**Re: Conceptual Value Engineering Change Proposal
Colorado Project No. BR 086A-027
State Highway 86 at Mitchell Gulch**

Lawrence Construction Company is submitting the following as a Conceptual Value Engineering Change Proposal in accordance with the Colorado Department of Transportation "Standard Specifications for Road and Bridge Construction, 1999, Section 104.07 (b)".

CONSTRUCTION SEQUENCE

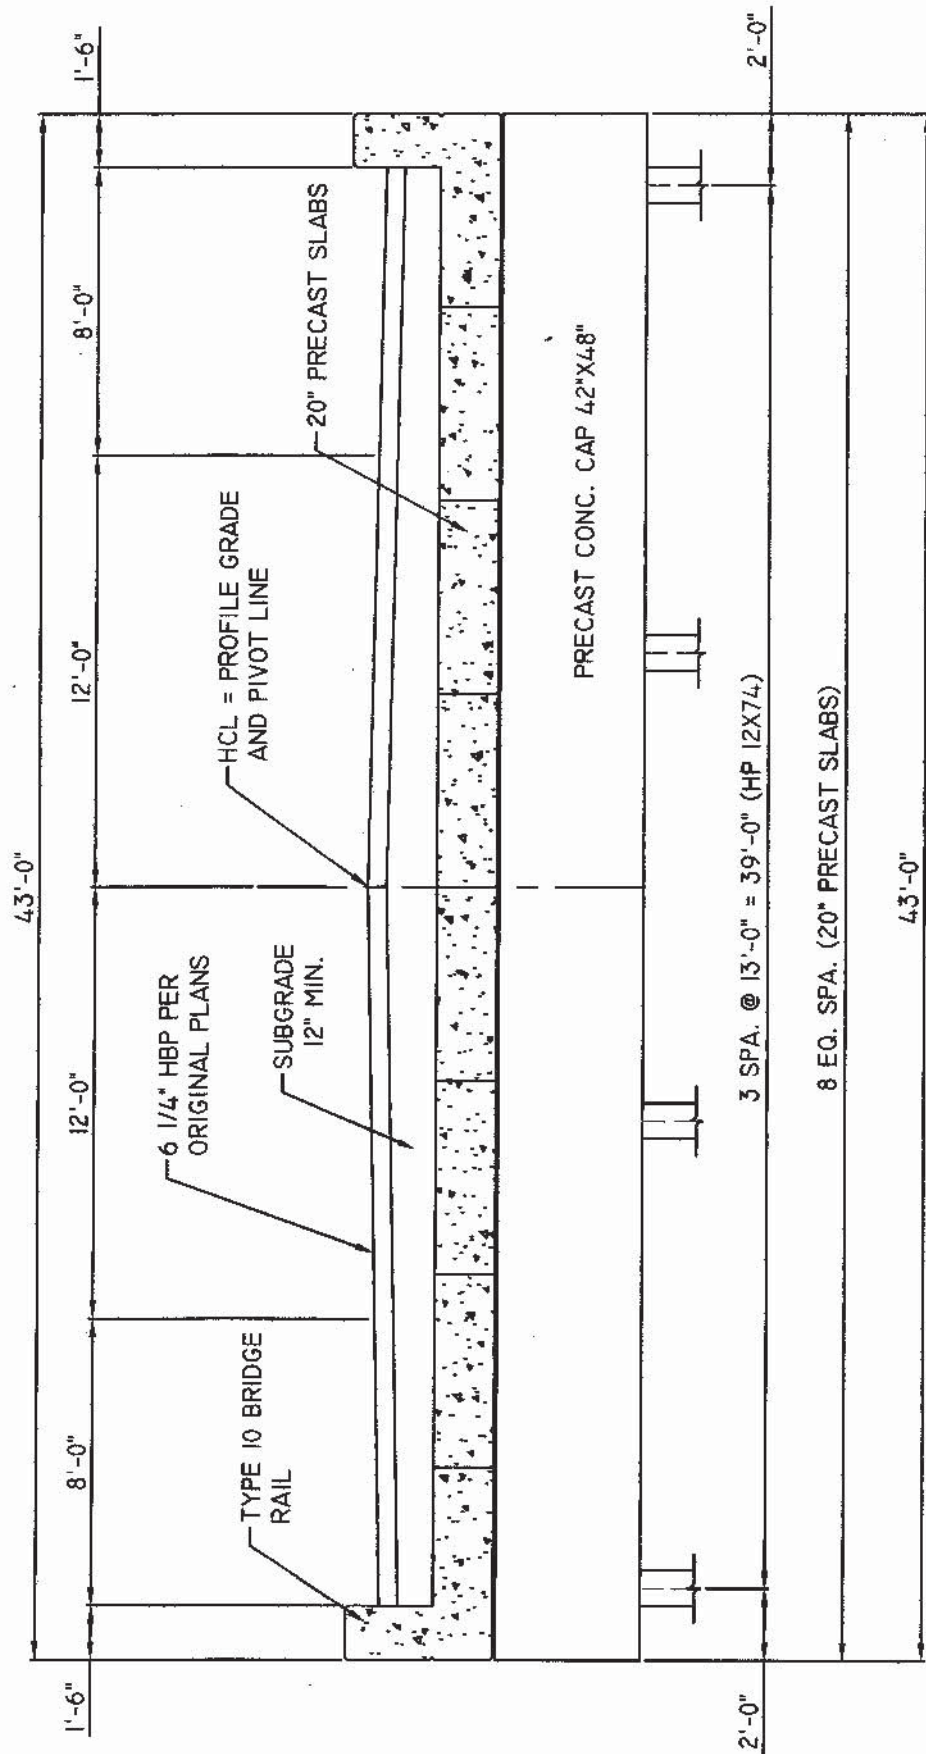
1. Install traffic control devices.
2. Construct gravel 2-lane temporary detour (bypass) on south side of existing bridge.
3. Drive abutment piling with traffic control. Set pile head slightly below surface of existing asphalt and patch with temporary pavement.

1. Remove existing structure.
2. Excavate around piling and cut piling to elevation of precast cap bottom.
3. Place precast abutment caps on piling and weld piling to embeds in bottom of cap.
4. Backfill behind and under abutment caps with flowfill.
5. Place riprap at face of abutments
6. Set 20" deep precast slabs and weld top slab plates between adjacent slabs.
7. Waterproof joints between slabs and between precast slabs and abutment caps at back of abutments.
8. Complete abutment backfills.
9. Place wingwall panels and backfill.
10. Place subgrade material and bluetop for HBP.
11. Pave and stripe.
12. Open to traffic.

1. Remove detour (bypass) on south side of bridge.
2. Fine grade shoulders and channel.
3. Construct approach-departure guardrail (Type 3) and end anchorages.
4. Place Type 10 bridge rail.
5. Complete roadway items.
6. Seed and mulch shoulders.

BRIDGE SECTION

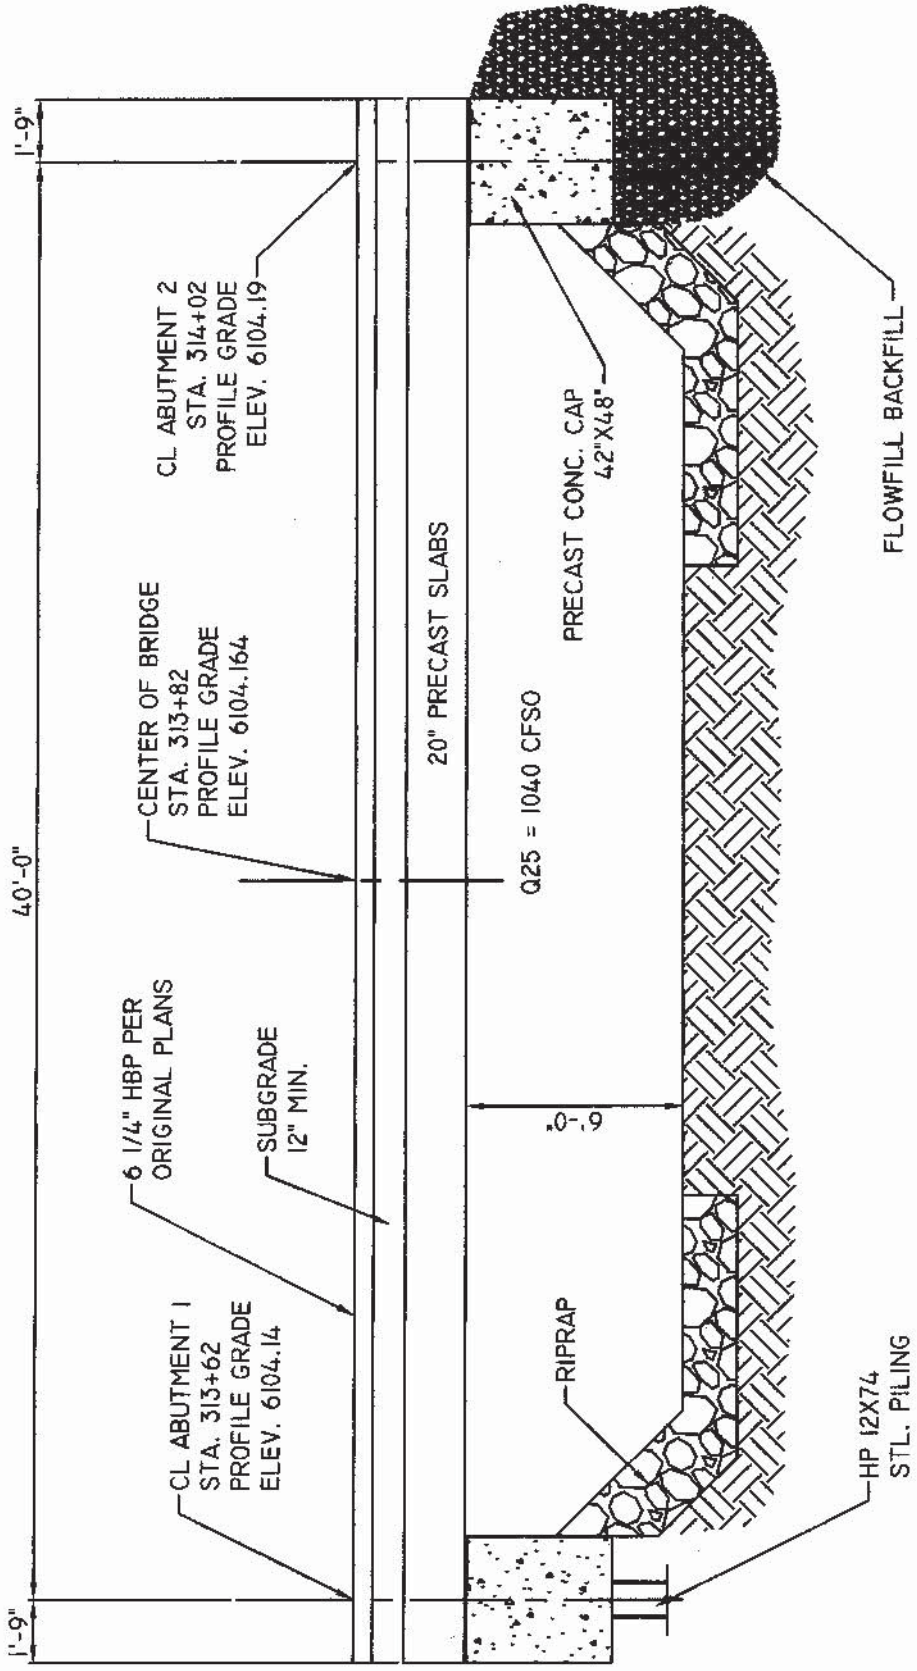
Lawrence Construction Company proposes to redesign the current triple concrete box culvert with a single span precast girder bridge. The conceptual design includes replacing the original triple concrete box culvert with a 43-foot wide bridge, which includes 2-12 foot driving lanes, 2-8 foot shoulders and 2-1.5 foot bridge rails (Type 10). Original horizontal and vertical alignments of the roadway and structure will be maintained. The proposed bridge length would be approximately 40-foot centerline of abutment to centerline of abutment and include the following:

1. The superstructure would be 20" deep precast/pre-tension concrete.
2. The abutment caps would be precast and conventionally reinforced approximately 42 inches wide x 48 inches deep with plate imbeds in the bottom at the pile foundation locations.
3. The foundation system would consist of HP 12x74 steel piling approximately 30 feet deep into bedrock formations. Each abutment would require 4 piles with a smaller size pile at the end of each wingwall. (Total 12 pile)
4. Joints between precast units will be sealed against moisture leakage and to provide structural continuity between units prior to placement of subgrade and pavement materials.
5. Backfill behind abutments will be flow fill to allow faster placement of superstructure and roadway elements.
6. Approach and departure guardrail will be required and will be Type 3.
